TC-W345

SONY[®] SERVICE MANUAL

SUPPLEMENT-1

Subject : Schematic Diagram change
Block Diagram

[AUDIO BOARD] — Component side —

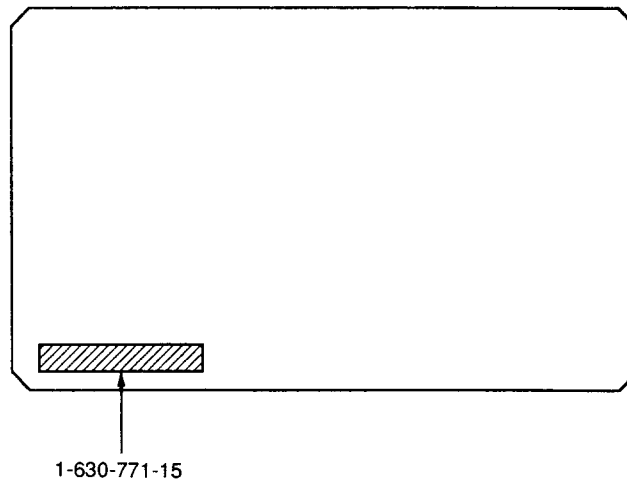
: indicates changed portion

Page	Ref. No.	Former	New
18	C153	_____	1-136-437-11 FILM 220PF 5% 630V
	C253	_____	1-136-437-11 FILM 220PF 5% 630V
19	CT301	1-141-225-00 CAP, TUNING, TRIMAR	_____
21	RV104	_____	1-241-767-21 RES, ADJ, CERMET 100K
	RV204	_____	1-241-767-21 RES, ADJ, CERMET 100K

RECORD BIAS ADJUSTMENT DECK B

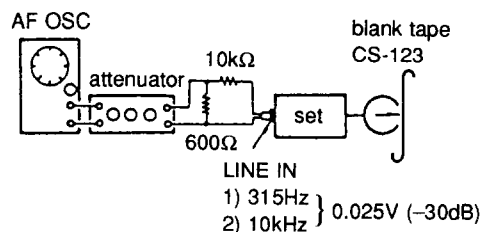
Playback the tape recorded in step 1. If the specification is not satisfied, adjust RV104 (L-CH), RV204 (R-CH) and repeat steps 1 and 2.

The LINE OUT level of 10kHz signal relative to that of 315Hz : -0.5dB to 0.5dB.
